**MODIFICATION TO TURNTABLE DRIVE ON 24L AND 30L MICROWAVE OVENS  
FROM ELC 05**

For a quality improvement on microwave ovens produced by ElcoBrandt (France) with **ELC05** listed below, the rotation system of the turntable has been modified. This enables to:

**KIT PART NO. 5028 00 04-00/8 OF THE NEW SYSTEM**

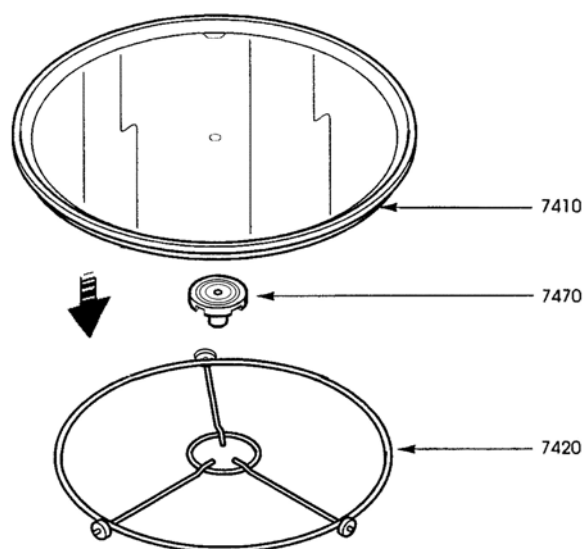
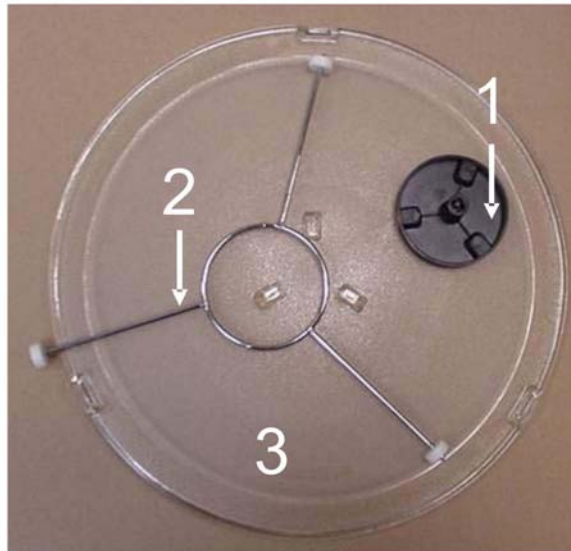
- Reduce the noise level during the rotation.
- Increase the load on the turntable.
- Avoid positioning incorrectly the shaft.

- 1 - SHAFT
- 2 - TURNTABLE METALLIC SUPPORT
- 3 - TURNTABLE

- PART NO. 5028 00 03-00/0
- PART NO. 5028 00 02-00/2
- PART NO. 5028 00 01-00/4

**Note:** The single components of the previous system are not interchangeable with the new ones. In place of the previous components it is possible to use the kit part no. **5028 00 04-00/8** which includes the new turntable part no. 5028 00 01-00/4, the new shaft part no. 5028 00 03-00/0 and the new turntable metallic support part no. 5028 00 02-00/2.
